THE COMMONWEALTH OF MASSACHUSETTS
WATER RESOURCES COMMISSION
100 CAMBRIDGE STREET, BOSTON MA 02114

**REPORT OF THE FINDINGS, JUSTIFICATIONS AND DECISION
OF THE WATER RESOURCES COMMISSION
Relating to the Approval of
AvalonBay's Request for an Interbasin Transfer
Pursuant to M.G.L. Chapter 21 § 8C**

May 10, 2007

Figure – Hydrographs showing flow reductions resulting from increased withdrawals to supply proposed Avalon Sharon development in Sharon, MA

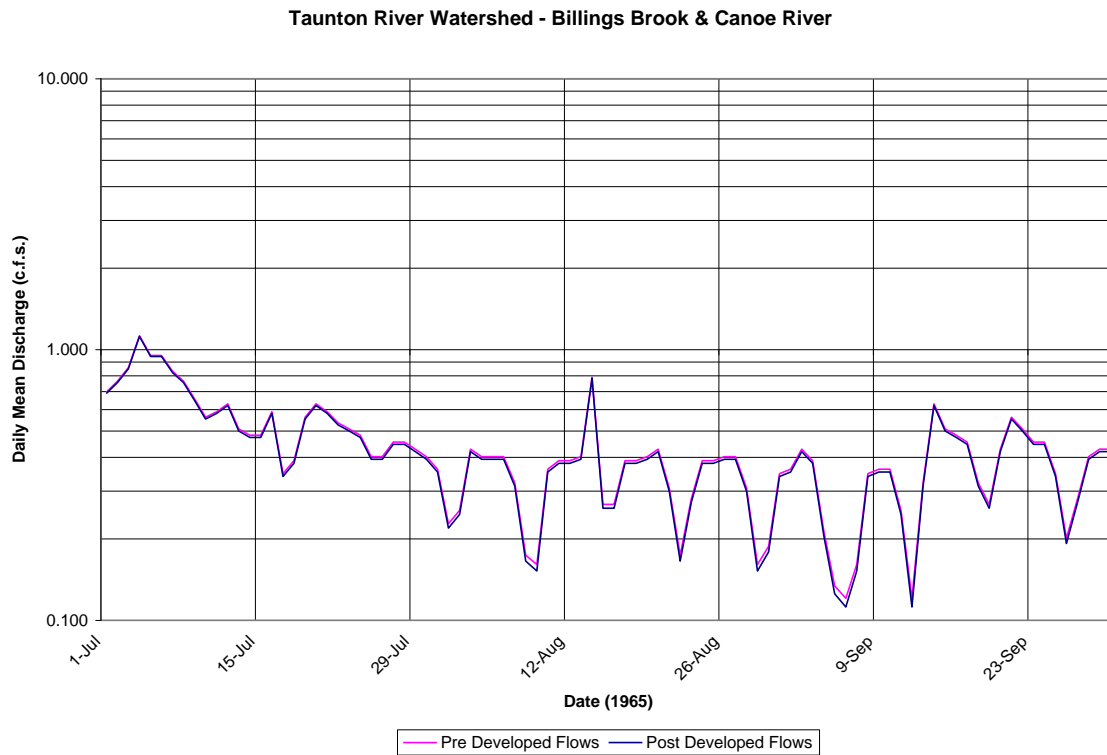
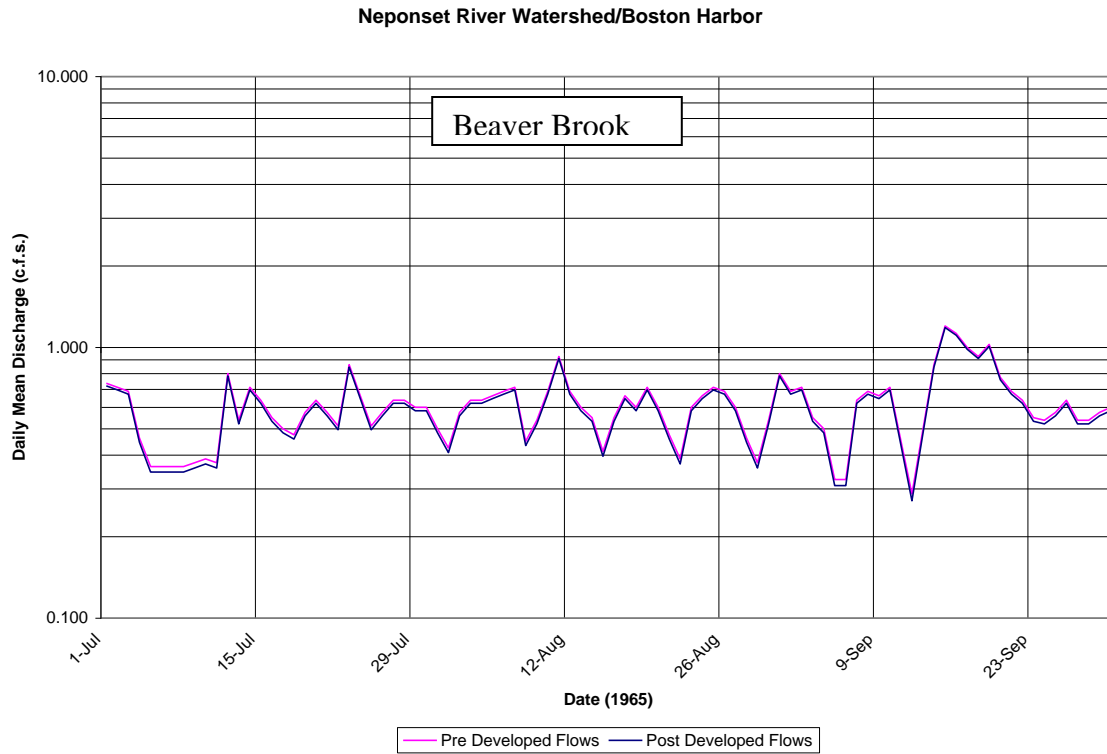
Because of the small sub-basin sizes in the reaches above the points of analyses, flows are very sensitive to the proposed transfer during periods of naturally low streamflow. The analysis is based on data from a downstream gage and indicates that even in the lowest period of record, streamflow will be maintained and will exceed about 0.11 cfs (50 gpm) and 0.28 cfs (125gpm) in the Taunton and Neponset River sub-basins. Ninety-five percent of the time the proposed transfer will be less than 1.3% and 2.2% of the total discharge from the Taunton and Neponset River sub-basins. However, anecdotal evidence indicates that some upper reaches of Beaver Brook may dry up during periods of low streamflow.

Based on the analysis performed for this transfer, the WRC concludes that reasonable instream flows will be maintained, however, the Town of Sharon, as the water withdrawer, may be contributing to streamflow depletion in the upper reaches of these sub-basins. Sharon is subject to the Water Management Act and any permit issued for the Town is expected to require town-wide conservation measures during low flows, which should mitigate the impacts of this transfer.
